1948-53 LAND-ROVER

STEERING

**COMPLAINT : WHEEL WOBBLE OR WHEEL SHIMMY**

### FITTING STRENGTHENING PLATE TO DASH PANEL

Fig. 1. Fitting dash strengthening plate.

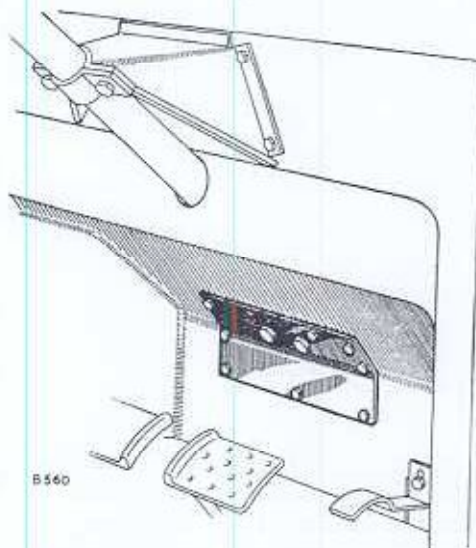
1. Remove the steering unit.
2. Offer up the strengthening plate Part No. 302536 on the driver's side of the dash panel as shown at Fig. 1 in such a position that it gives maximum support at the steering box fixings. Holding the plate in position, drill through the two  $7/16$  in. (11,1 mm.) steering box securing holes.
3. Replace the steering unit, securing it together with the plate, by means of the original fixings.

4. Where facilities permit, arc weld the plate to the dash.

NOTE: If welding equipment is not available, drill a series of  $1/4$  in. (6,4 mm.) holes round the periphery of the plate and secure with bolts ( $1/4$  in. B.S.F. x  $5/8$  in. long, Part No. 215053 or suitable alternative), spring washers and nuts.
